MEMORANDUM

To: Bayonne Zoning Board of Adjustment

Re: 177 3rd Street, LLC
ZBA Application Z-25-007
Bulk Variance
Block 371, Lot 2
33 E. Second Street / CR 704
R-2 Detached/Attached Residential District

Date: August 17, 2026

Recent StreetView Image of 33 E. 2nd Street

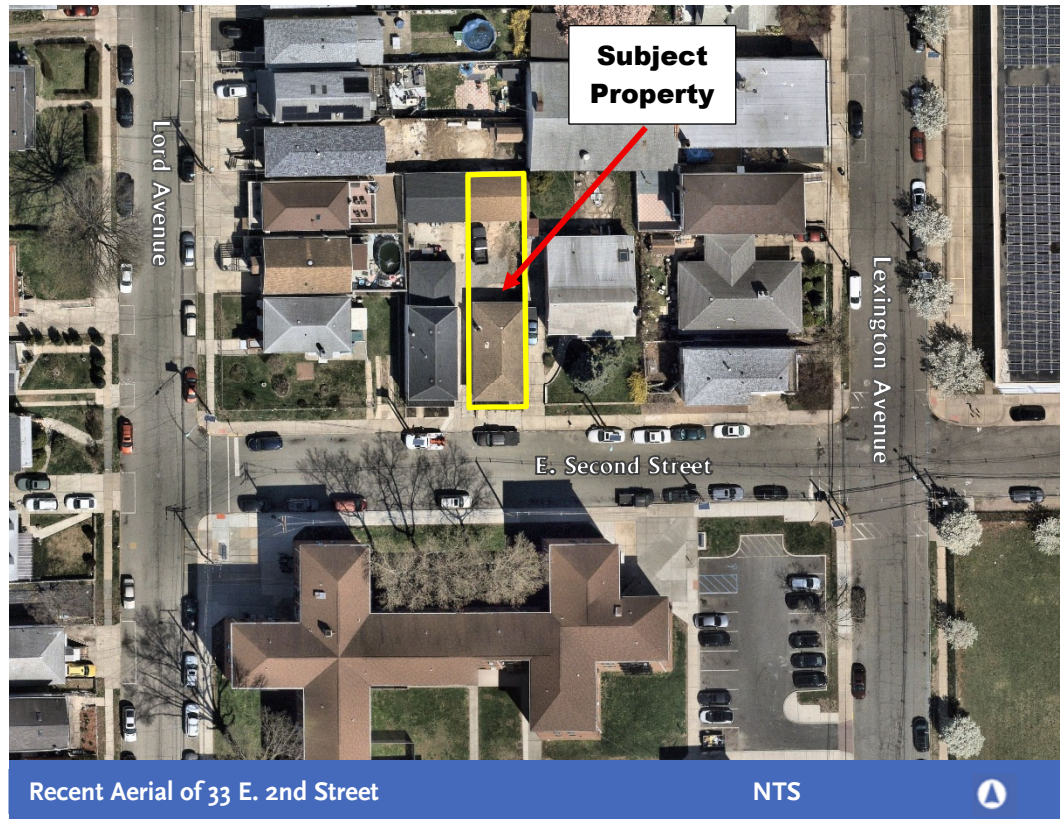
1.2. Existing Conditions. The subject property is an existing 3,179 sf. lot located on the north side of E. 2nd Street, between Lord and Lexington Avenues. It contains a one-story, single-family dwelling and a one-story accessory garage. The front terrace extends into the right-of-way approximately 2.5 feet and the steps up to the terrace about another 4 feet. There are existing driveways on either side of the lot that extend to the rear of the property on adjoining Lots 1 and 3. The pavement for both driveways extends up to the building's foundation. A small area of the rear yard is not paved, but will be covered by the proposed addition.

- 2.3. **Existing Non-conformities.** The existing lot is non-conforming for minimum frontage and the building is non-conforming for minimum front yard setback, minimum side yard setback, combined side yard setback and lot coverage. As noted, the existing front porch/terrace extends into the right-of-way of E. 2nd Street. The existing garage is also non-conforming for rear and side yard setbacks. **The proposed front, side and combined side yard setbacks and lot coverage will be affected by the proposed improvements and will require variances pursuant to *N.J.S.A. 40:55D-70.c*. City Council approval is also required to permit the encroachment in the right-of-way.**
